7.2 Setbacks

It is considered that the impacts can be suitably mitigated and/or managed to ensure a satisfactory level of environmental performance and the Department recommends that the Concept Plan be approved pursuant to Section 75O of the Act.

Diagrams 20 and 21 – Presentation of Upper Tower form and proposed and compliant Walker Street setbacks (Source: PPR)

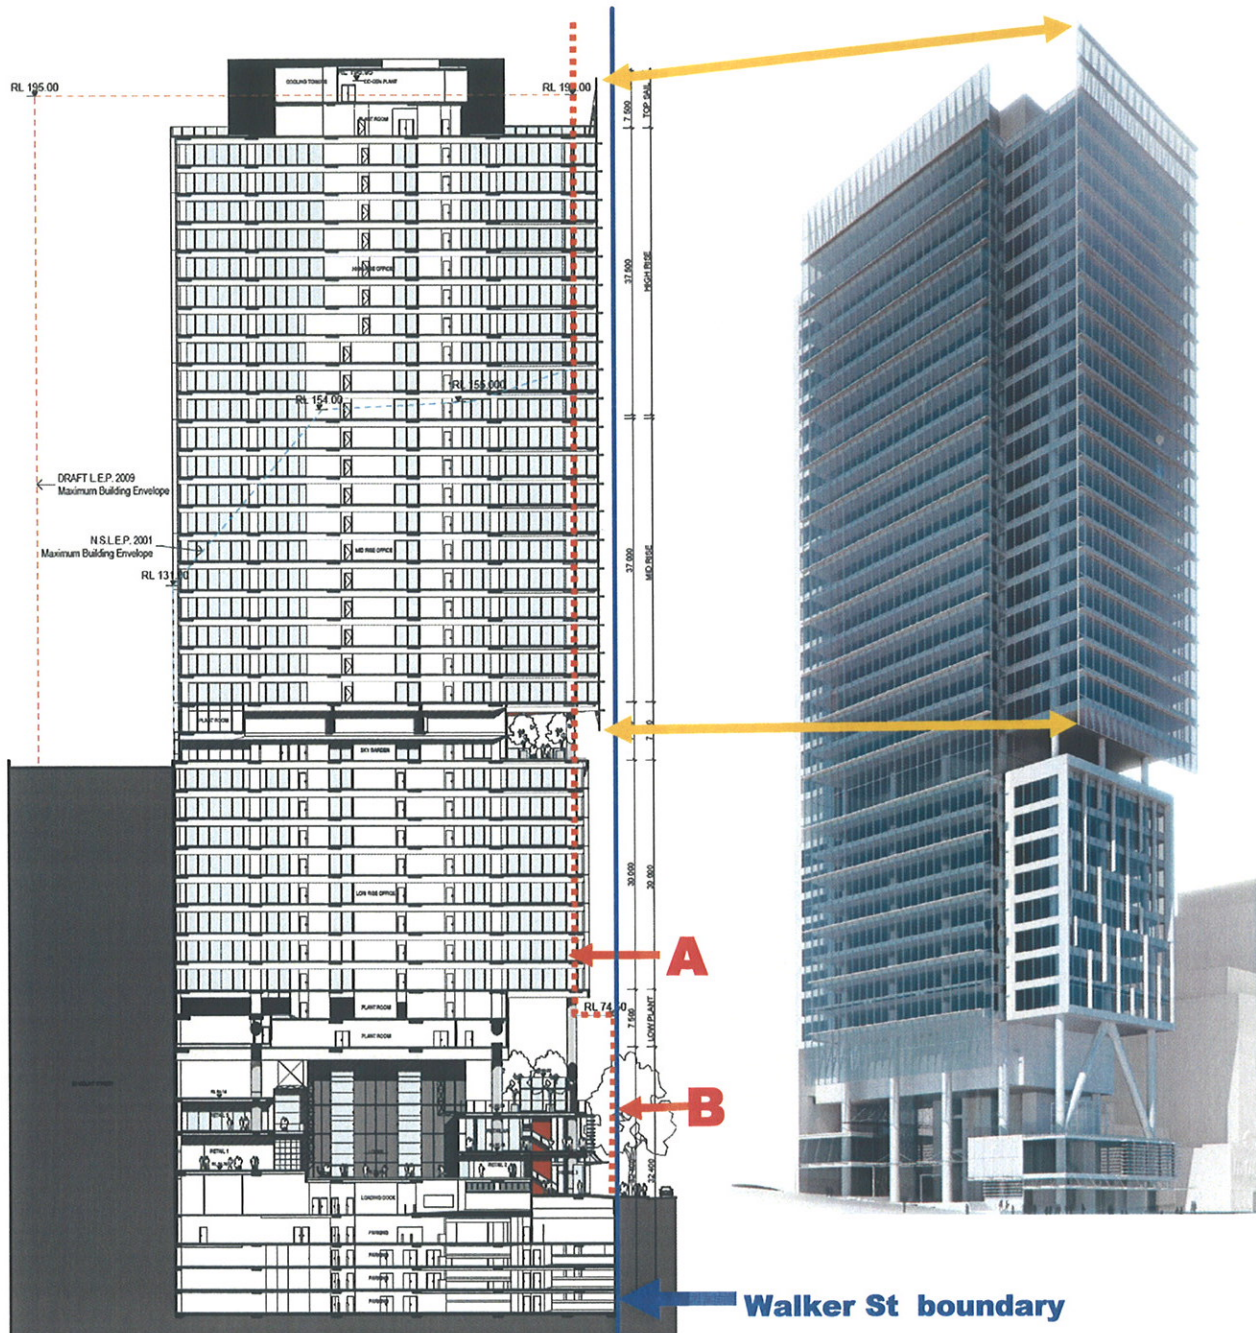
However, there is a concern raised regarding the variation to the setback control to Walker Street in respect to the upper levels of the proposed tower (Levels 17 to 36). The Council and the Council's Design Excellence Panel also identified this as an area of concern.

The PPR proposal provides a weighted average setback of 3.58 metres to Walker Street, and in this case, the calculated setback is somewhat distorted by the 14.1 metres setback of Levels 3 to 6 being the area known as the reverse podium which disproportionately increases the average.

The actual setbacks to Walker Street vary considerably from the 3.58 metre weighted average as summarised below;

Level 1 to 2 (podium) =	3.3metres
Levels 3 to 7 (reverse podium) =	14.1metres
Levels 7 to 16 (mid tower) =	4.2 metres (to glass line)
Levels 17 to 36 (upper tower) =	2.2 metres

A is the alignment of the North Sydney Centre DCP 2002 above podium level height and setback control to Walker Street which is **5 metres**.

B is the alignment of the North Sydney Centre DCP 2002 podium height and setback control to Walker Street which is a maximum height of 4 storeys and a zero setback.

The upper tower projects forward of the building line below by up to 2.0 metres, and being an element of 20 storeys in height, this feature of the proposal is considered to be a discordant element in the Walker Street streetscape, and may set an undesirable precedent for other development (refer **Diagrams 22 and 23** below).

Accordingly, it is recommended that the upper levels of the tower to Walker Street be required to be setback a further 2.0 metres to an overall setback of 4.2 metres to match Levels 7 to 17 below.

A condition of approval is recommended to amend the building setback. The subject modification would conform to the position of the Council and the Design Excellence Panel which recommended that the tower should not project forward of the levels below on the Walker Street frontage.

Diagram 22 – Photomontage looking north along Walker Street (Source: PPR)

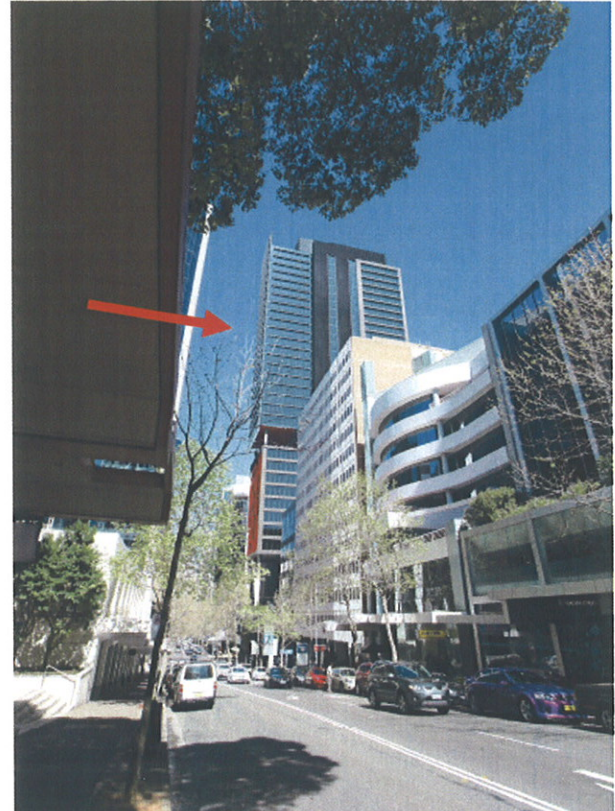
This cantilevered tower element is a feature of the proposal which is assessed to be uncharacteristic of the prevailing built form in Walker Street and is not consistent with the desired future character sought by the DCP controls.

Diagrams 24 and 25 – Impact on views at top level of Beau Monde from the LEP 2001 envelope (BLUE), the Draft LEP envelope (RED) and the proposal (Source: PPR)

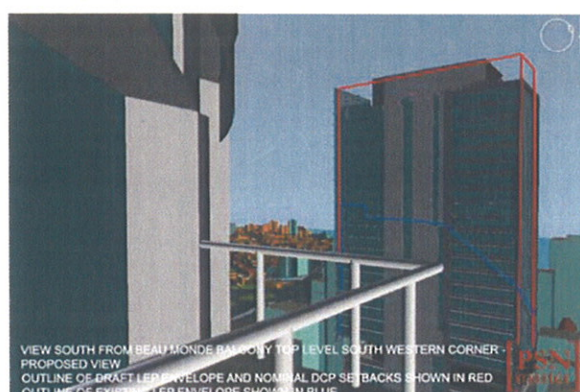
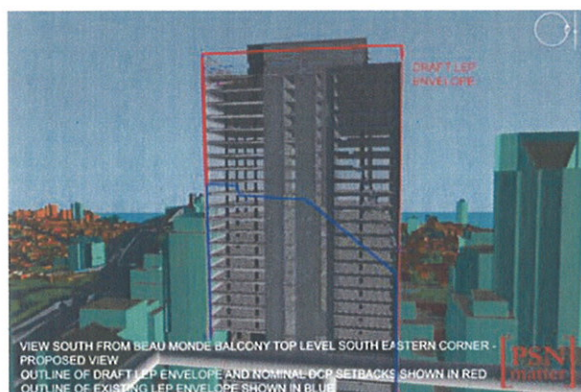
The apartments from approximately Levels 28 to 36 would maintain due southerly views under the LEP 2001 envelopes in Mount Street (refer **Diagrams 24 - 27** below).

As detailed in **Diagrams 24 - 27** above, the additional 4.7 metres height of the current Mount Street proposal will have a minor additional impact on the Beau Monde building beyond that imposed by the Draft LEP 2009 envelope (RL 195 metres) and does not result in any additional loss of southerly Sydney Harbour Bridge, Harbour or Sydney CBD skyline views.

Diagram 28 – Arc of Harbour and City views from Beau Monde
in relation to Mount Street site (Source: Google Maps)

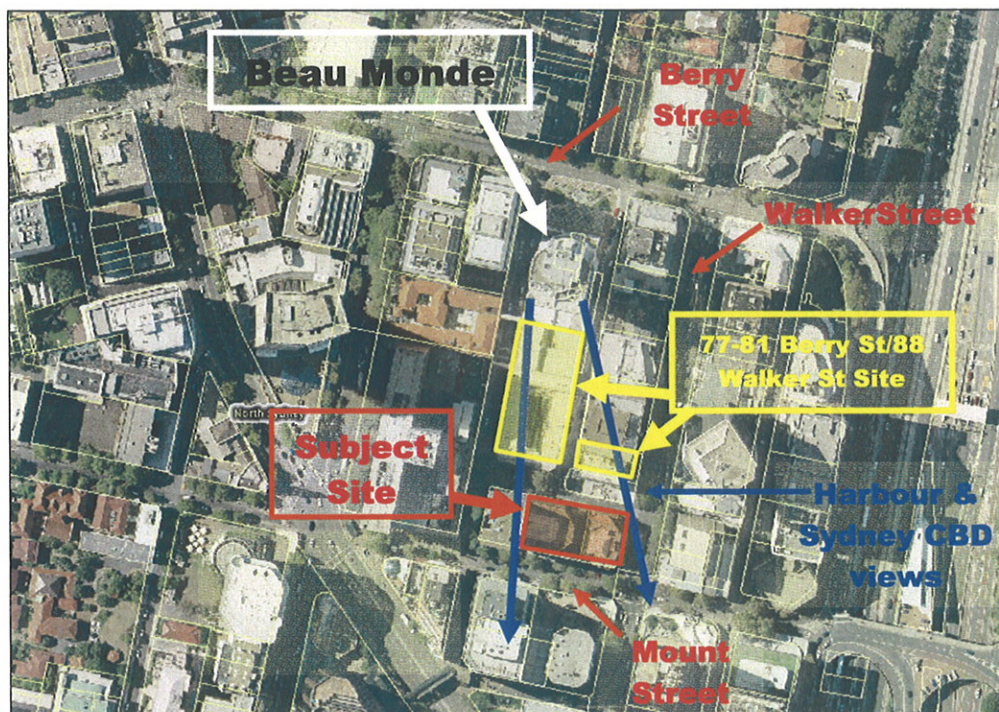
The existing southerly and south-easterly views will be significantly affected as a result of the Draft LEP building envelopes on the 77-81 Berry Street site as detailed below in **Diagram 28 & 29** below. It is evident from these diagrams that that the 77 – 81 Berry Street Draft LEP height envelopes and the existing LEP 2001 Walker Street envelopes remove existing views from Beau Monde below RL 170 metres (approximately Level 35 of the Beau Monde building).

In terms of the orientation of the arc of view, it is evident that the Mount Street site is located in the "shadow" of the Berry Street/Walker Street Draft LEP envelopes (and as approved), and thus the actual impact of the Draft LEP Mount Street envelope is limited to Level 36 of the Beau Monde building being the only level with a view above RL 170 metres.

Level 36 will lose a narrow southerly/south-south easterly arc of view of Sydney harbour and the Sydney CBD as a result of the current Mount Street proposal.
